PREVOST

WARRANTY BULLETIN

Wb11-18

SUBJECT: WELDING BEAD VERIFICATION – ENGINE

PART 2 - ELECTRONIC MODULES DISCONNECTION AND WELDING

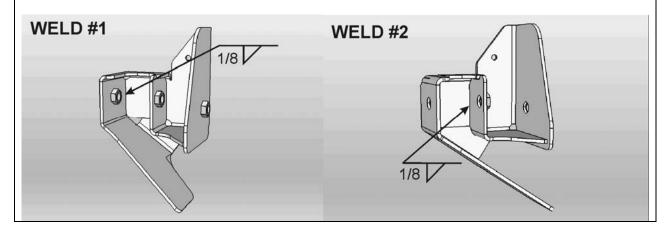
4. If weld #1 or #2 is missing, then proceed to the corrective measure of part 2.

- 1. Before undertaking welding on the support, it is absolutely necessary to disconnect the electronic modules as they may be damaged. Refer to procedure «MULTIPLEX MODULES DISCONNECTION PROCEDURE PRIOR TO WELDING PR060041».
- 2. Place the ground clamp as close as possible to the welding area. Add any missing weld bead. Perform a 3mm (1/8") fillet weld.
